MONTGOMERY COUNTY HISTORIC PRESERVATION COMMISSION
STAFF REPORT

Address:	10304 Kensington Parkway, Kensington	Meeting Date:	1/10/2024
Resource:	Primary One Resource Kensington Historic District	Report Date:	1/03/2024
Applicant:	Paul Longo	Public Notice:	12/27/2023
Review:	HAWP	Tax Credit:	Partial
Permit Number:	1016525 REVISION	Staff:	Rebecca Ballo
Proposal:	Revision to previously approved HAWP for partial demolition, building addition, and fenestration alterations.

The applicant proposes partial demolition, building addition, and fenestration alterations. This HAWP revision is for changes to the fenestration pattern on the rear elevation and addition, and to a change in the window and door materials from all wood to wood clad aluminum.

Fig. 2: Previously approved right elevation (above) and proposed right elevation (below).

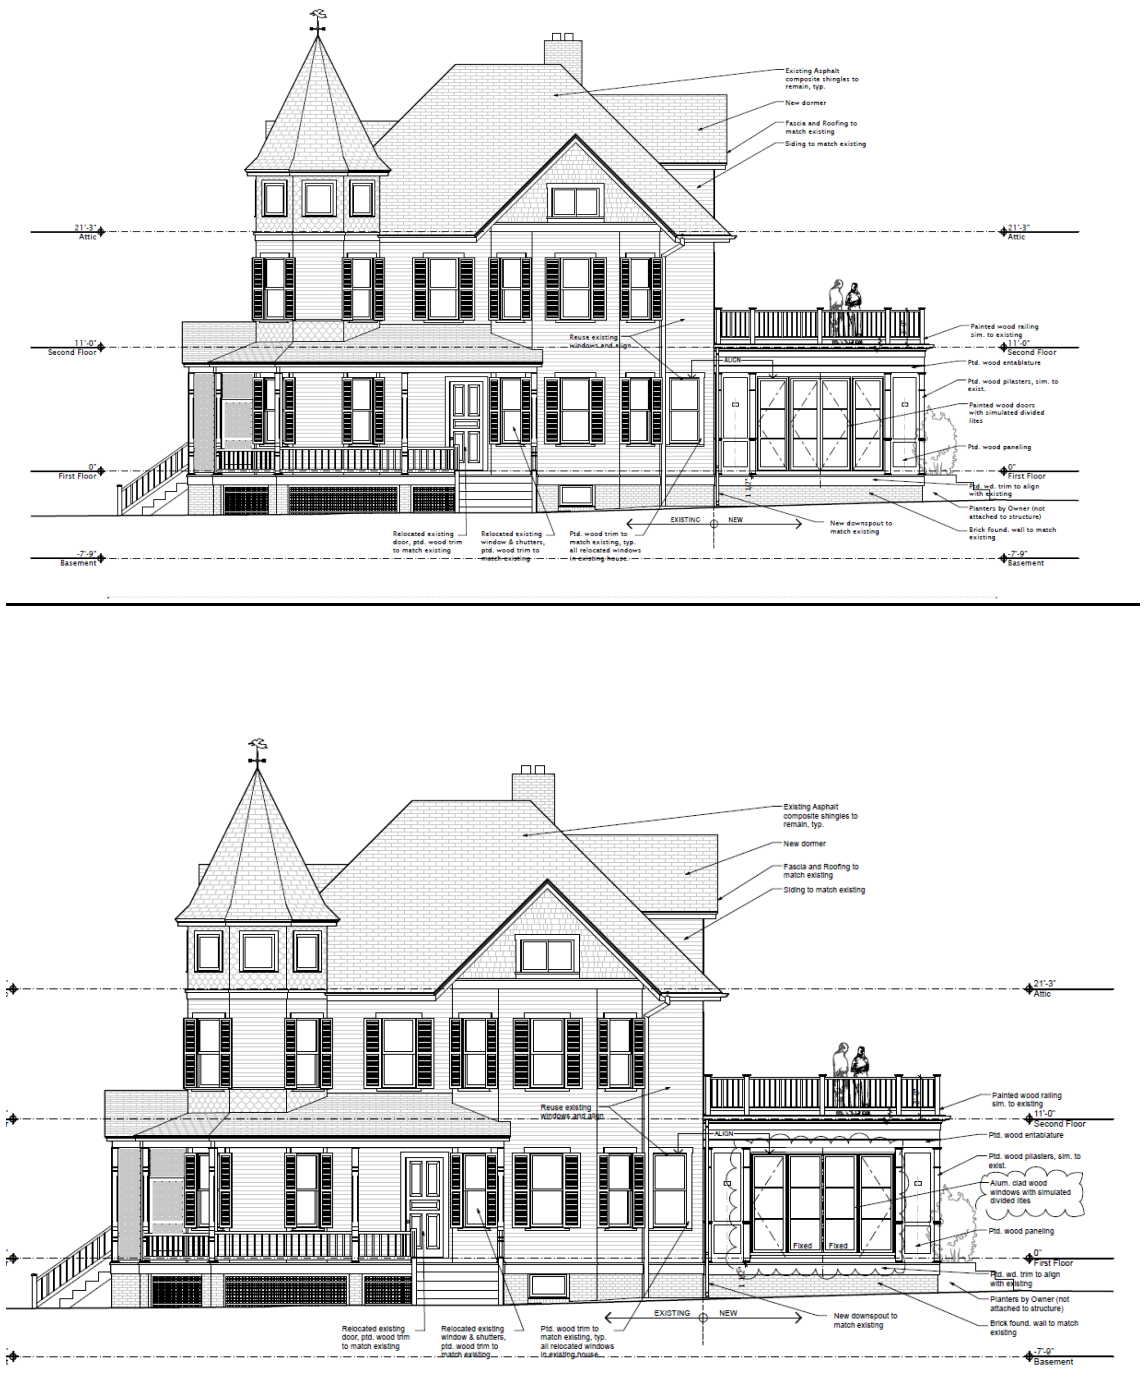
Per the applicant's submittal dated 12/18/2023, this HAWP revision proposes changes to the door swings, fenestration configurations, and materials on the rear addition and in the rear elevation. The newly proposed window schedule is called out in Sheet T3 of the packet. The applicant originally proposed all wood windows and doors in the rear elevation and in the rear addition. After reviewing detailed specifications for wood windows and doors, the applicant has proposed changing to Loewen aluminum clad instead; this material alteration would allow for a slimmer muntin profile which will give the addition the lighter appearance intended by the project architect and the HPC. The alterations in the window and door swings are to accommodate retractable screens. The change in the fenestration configurations and the swings will have no impact on the appropriateness of the project. Staff finds that with these alterations the project continues to meet the criteria of Chapter 24A-8(b)(1), (2) and (d), and the *Vision of Kensington*. Staff further finds that the proposal will not substantially alter the exterior features of the historic resource and is compatible in character with the district and the purposes of Chapter 24A, and that it meets the *Secretary of the Interior's Standards* #2, #9, and #10. All other findings, descriptions, and recommendations from the first version of the approved HAWP#1016525 still apply.

Fig. 3: Previously approved rear elevation (above) and proposed rear elevation (below).

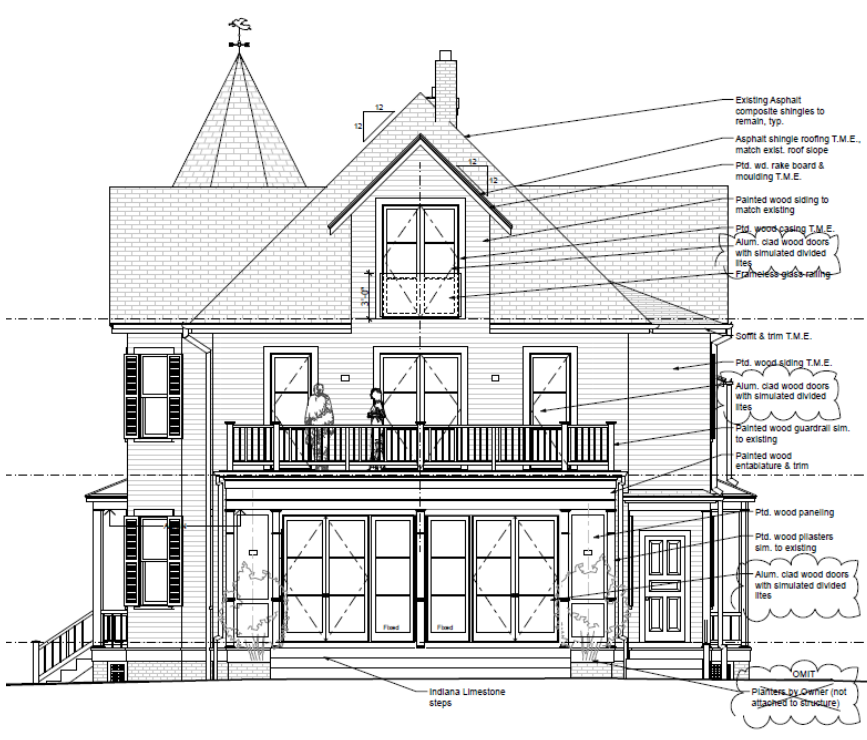
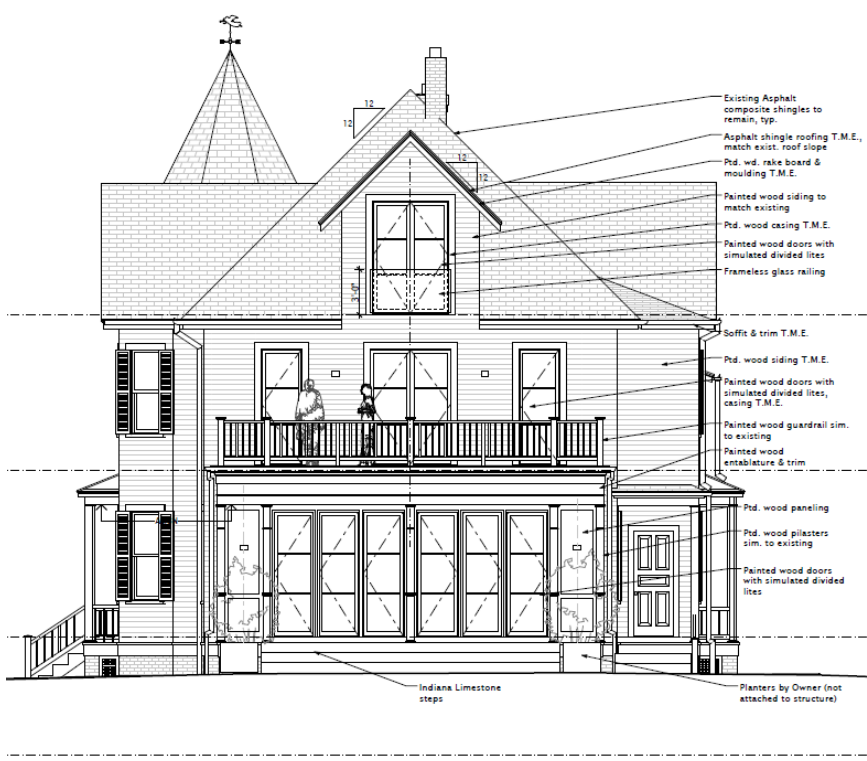
12/18/23: As an amendment to the original project description, we are proposing to change the First Floor Exterior doors facing the rear elevation to Outswing doors in order to install retractable screen doors on the inside, since the Owners requested to have screens for these doors. The windows in the side elevations are either fixed or casement windows, as per our window and door package submitted for review to HPC on 11/29/23.
